PUBLIC INTEREST REVIEW FOR GROUND WATER APPLICATIONS

SUBJECT: Application G- 17571 Supersedes review of _____
Date of Review(s) _____

A. GENERAL INFORMATION: Applicant's Name: Juniper Basin Ranch County: Harney

Application G-17571, Juniper Basin Ranch

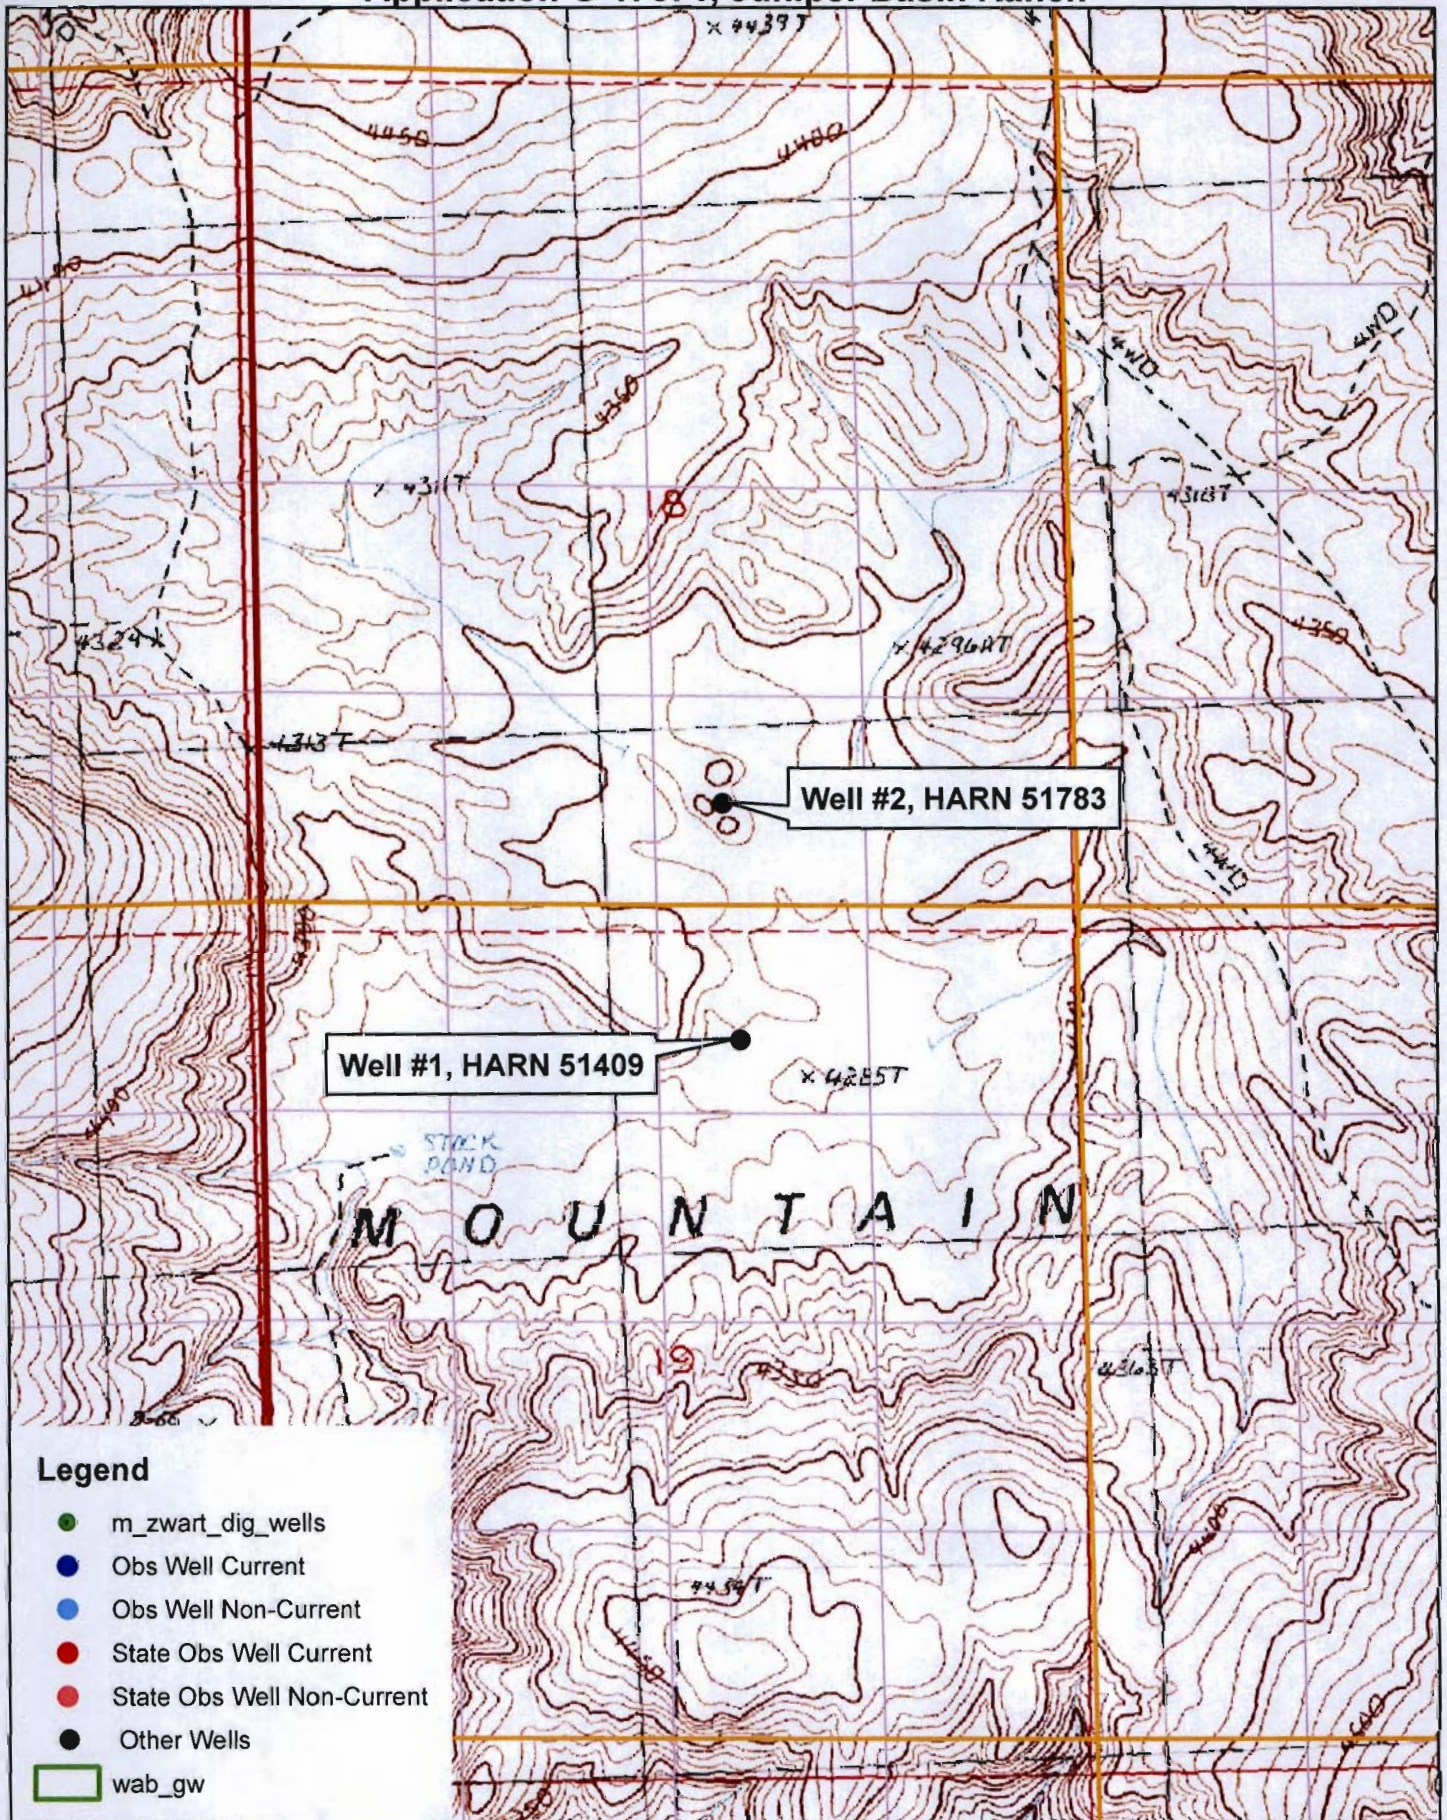
Basis for aquifer confinement evaluation: The static water level was the same as the depth where water was first found in both wells. The most current water level for Well #1 indicates a water level decline since 2007.

Basis for aquifer hydraulic connection evaluation: The lakes are the likely discharge areas for the regional ground-water system. No perennial surface water sources are closer than the lakes.
